CITY OF ALBUQUERQUE

Re: Generations at West Mesa
5701 Avalon Rd. NW
Request for Certificate of Occupancy
Transportation Development Final Inspection
Engineer's/Architect's Stamp dated 1-22-16(DRB) (K11D084)
Certification dated 11-19-19

RE: Generations at West Mesa
5710 Avalon rd. NW
Albuquerque, NM 87105
Zone: SU-1
Submittal: SDP for Final C.O.

DRAWING NAME
**SITE DEVELOPMENT
PLAN FOR BUILDING
PERMIT**

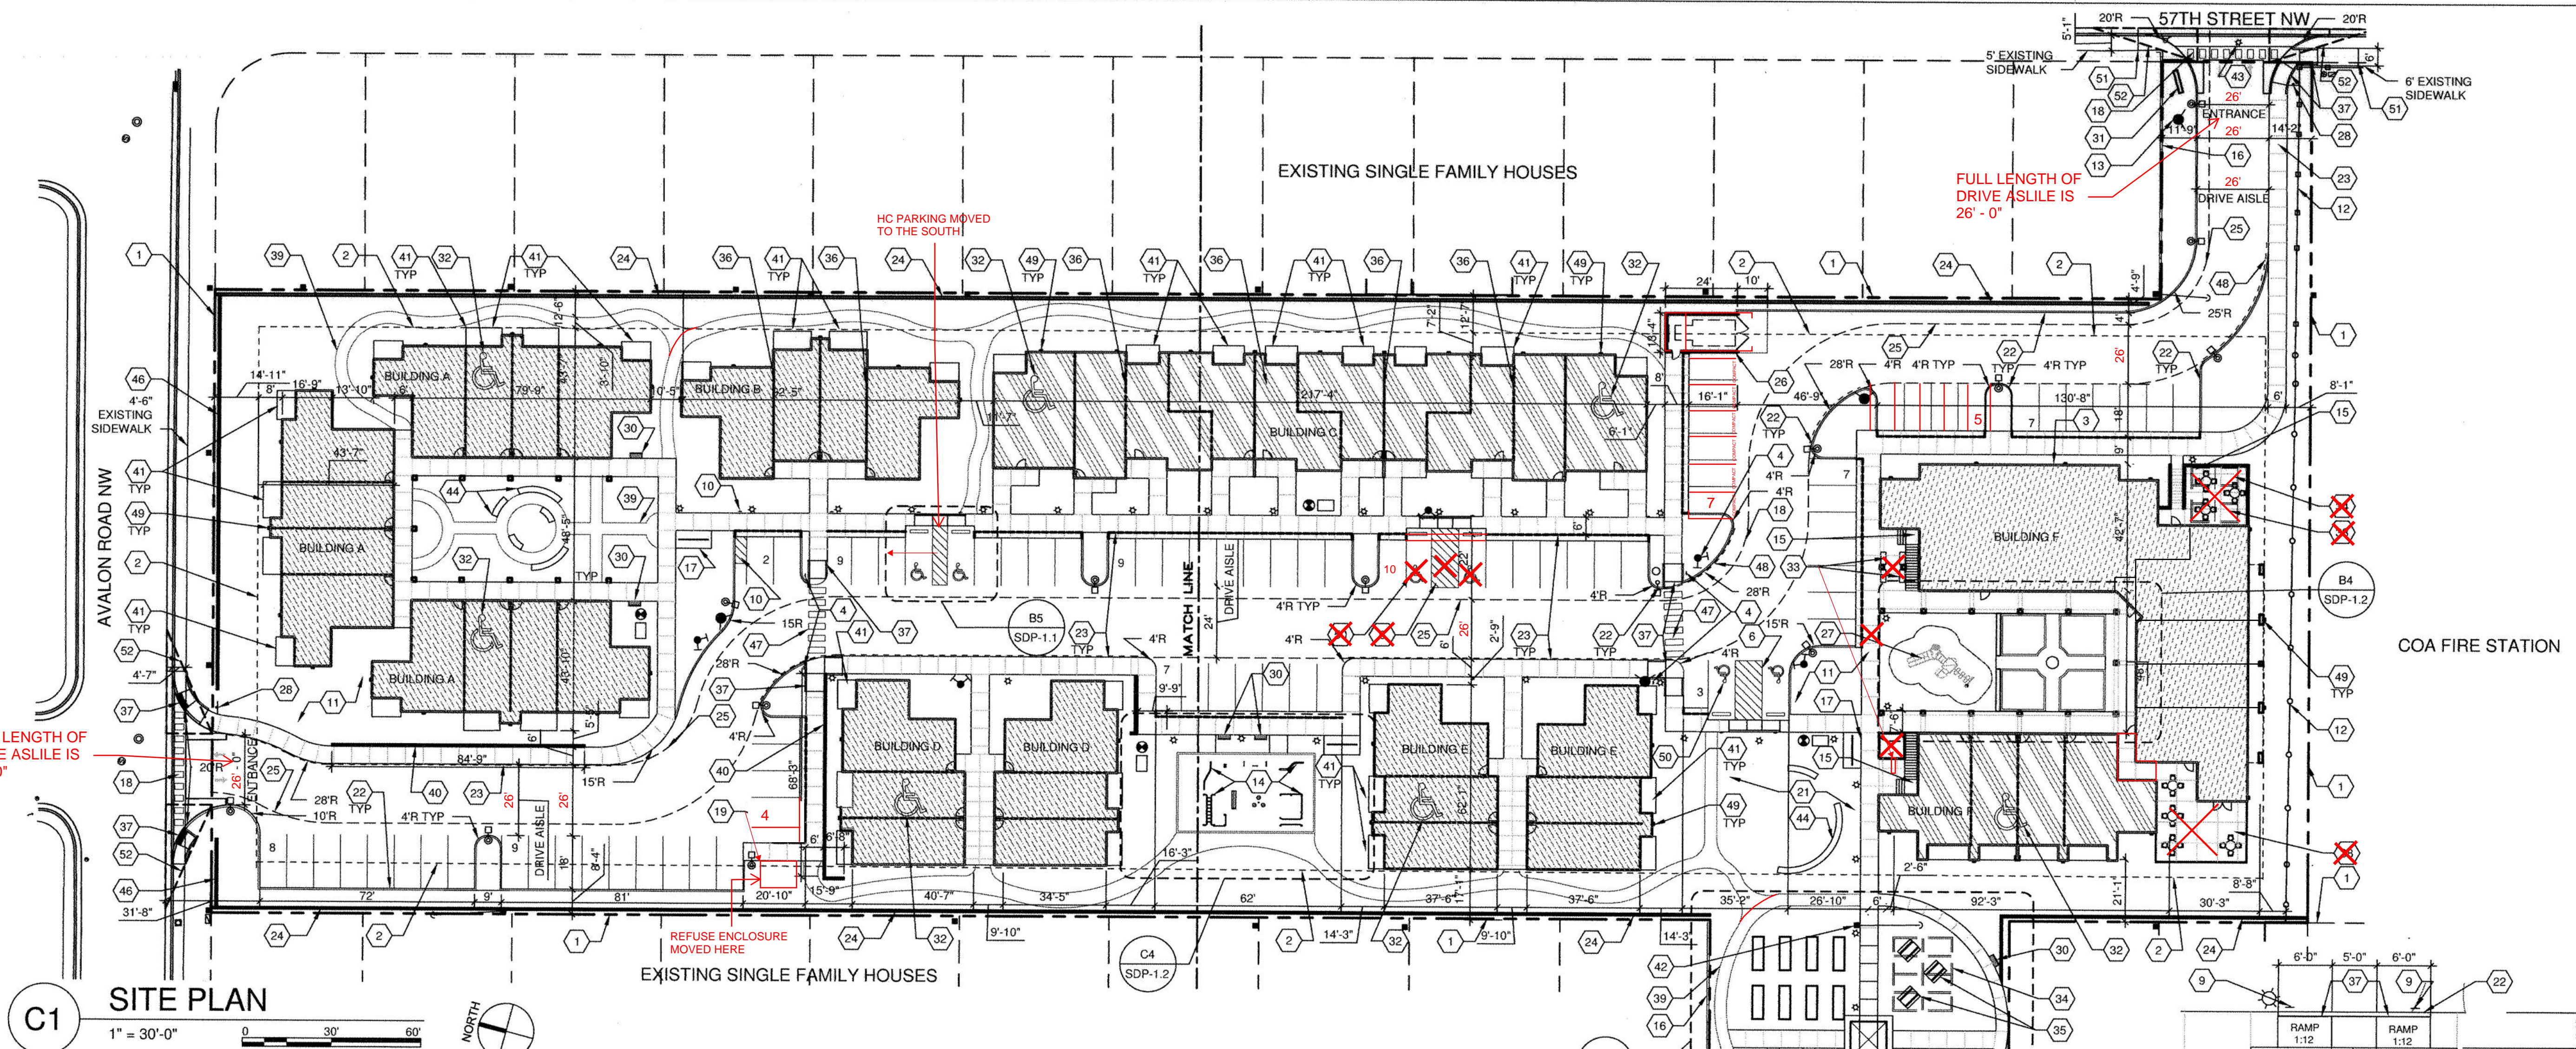
Dekker/Perich/Sabatini visited the project site on November 19, 2019 to verify construction was in accordance with the attached Site Development Plan. The following items differ from the original plan. However, the design intent is the same as what was approved on the Site Development Plan:

1. The drive aisle along the entirety of the site has been increased to 26'-0" per the request of the fire marshal.
2. The convenience refuse enclosure south of building D has been relocated to the west and an additional parking space has been included in this area.
3. The accessible parking west of building B has been relocated two spaces to the south.
4. The accessible parking west of building C has been removed do to VE. (the site requirements are maintained)
5. Parking layout north of building C have been revised to include an additional parking space.
6. Parking layout east of building F have been revised to include an additional parking space.
7. Mailboxes have been relocated to the west end of building F.
8. Seating areas on the north end of building F have been removed due to VE.
